Technical Service Bulletin: TSB104264

Released Date: 21-Dec-2010

New Cylinder Head Gaskets

Figure 1, New cylinder head gasket.

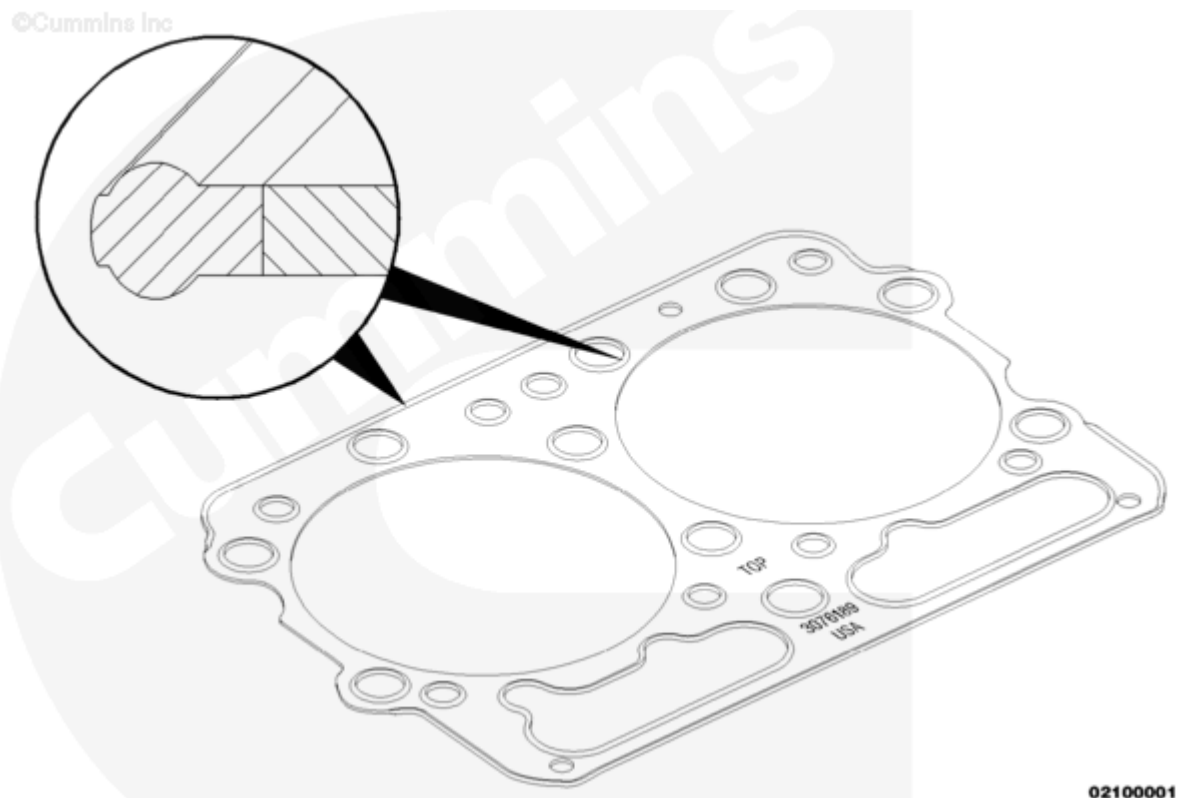
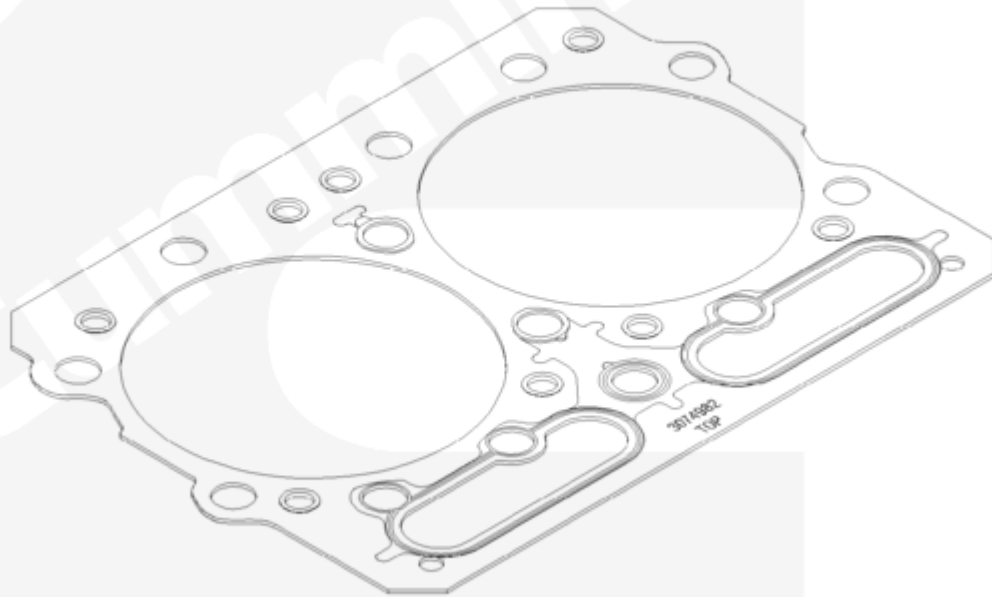
A new cylinder head gasket, Part No. 3076189 has been released for all NT and N14 engines. This new cylinder head gasket is a fully molded gasket and supersedes cylinder head gasket, Part No. 3074982.

The difference between the old and the new cylinder head gasket is that the new gasket does **not** have grommets or the molded cluster. All sealing on the new cylinder head gasket is done with edge molded rubber.

Refer to Figures 1 and 2 for a comparison of the old and new cylinder head gaskets.

The use of this new cylinder head gasket requires clean head and block surfaces. These surfaces can be cleaned with any safety solvent. The use of soluble oil in (water pump lubricant) the cooling system will damage the rubber seal in the new gasket. Do **not** use soluble oil in the cooling system when the new gasket is being used.

Figure 3, Opening box diagram.

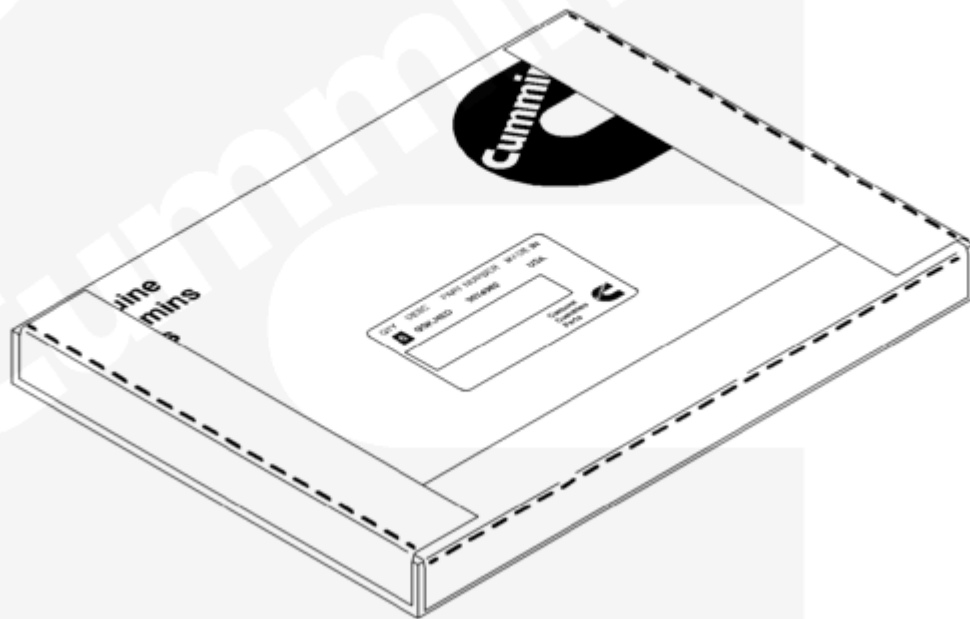
Care must be taken when opening the box so that the gaskets are not cut. Lay the box flat with the label facing up. Cut only the tape along the dotted line as shown in Figure 3.

Refer to Figure 3 for instruction diagram on opening the quantity packed box of the new fully molded cylinder head gaskets, Part No. 3076189. It is important to follow these instructions to prevent cutting the gaskets when opening the box.
